Access Compliance Report

Public Rights-of-Way

Intersection ID: 19595	Main Street: DUNFRIES_RD	Cross Street: NEDMORE_CT	Location: SW
ADA ID: 30F518A61D8E	Ramp Type: BlendTrans2	Initial Pass/Fail: Fail	Overall Compliance: No
		Severity Score: 25

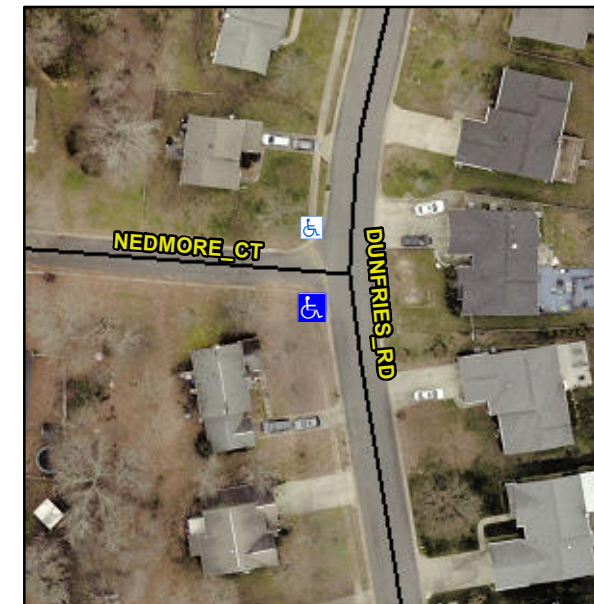
Not Found, R304.5.3

Compliance	Description	Data	Compliance	Description	Data
N/A	Ramp Length (in)	55.0	Yes	BlendTrans Slope (%)	2.9
Yes	Ramp Width (in)	48.0	No	BlendTrans XSlope (%)	7.2
N/A	Flare Type LT	N/A	N/A	Flare Type RT	N/A
N/A	Flare Slope LT (%)	N/A	N/A	Flare Slope RT (%)	N/A
N/A	Flare Traversable LT?	N/A	N/A	Flare Traversable RT?	N/A
N/A	Landing Length (in)	N/A	N/A	DWS Provided?	N/A
N/A	Landing Width (in)	N/A	N/A	DWS Contrast?	N/A
N/A	Landing Slope (%)	N/A	N/A	DWS Length (in)	N/A
N/A	Landing X Slope (%)	N/A	N/A	DWS Full Width?	N/A
N/A	Landing Curb? (Y/N)	N/A	N/A	DWS Offset (in)	N/A
N/A	Shared Landing?	N/A			
N/A	Gutter Ponding?	N/A	N/A	Gutter Slope (%)	N/A
N/A	Gutter Lip Ht (in)	N/A	N/A	Gutter X Slope (%)	N/A
N/A	Painted X Walk1?	No	N/A	Painted X Walk2?	No
	X Walk 1 Direction	To E		X Walk 2 Direction	To N
	X Walk 1 Width (in)	N/A		X Walk 2 Width (in)	N/A
	X Walk 1 Slope (%)	1.8		X Walk 2 Slope (%)	6.2
	X Walk 1 X Slope (%)	5.6		X Walk 2 X Slope (%)	3.5

N/A	Ramp inside XWalk1?	N/A	N/A	Ramp inside XWalk2?	N/A
	Road Slope (%)	6.4		Clear Space?	N/A
	Road X Slope (%)	0.7	N/A	Clear Space to XWalk (in)	N/A
N/A	Any Obstructions?	N/A	N/A	Storm Grate/Utility Hazard?	N/A
	Obstruction Type			Storm Grate/Utility Type	
		N/A			N/A
			Yes	Surface Condition? (G/P)	Good
			No	Curb Slope (%)	11.7

Remove & Replace Curb Ramp With Two New Directional Ramps or Equivalent.
